Amendment proposals to Annex 3 to CEVNI

Note by the secretariat

1. Sketch for article 3.01, paragraph 1:

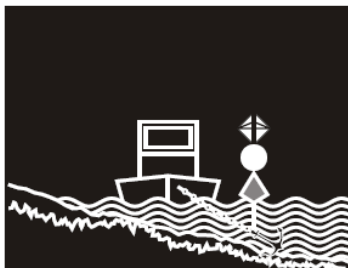
Assign the number "0".

61bis

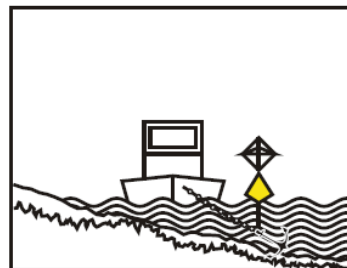
7. *Add* sketch 61bis

76

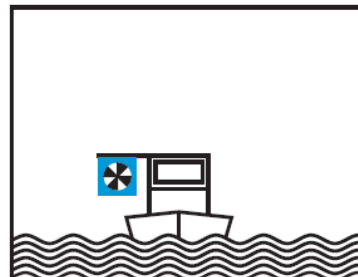
8. Sketches 66, 67: the Expert Group may wish to specify the transitional period.
9. *Add* sketch 76
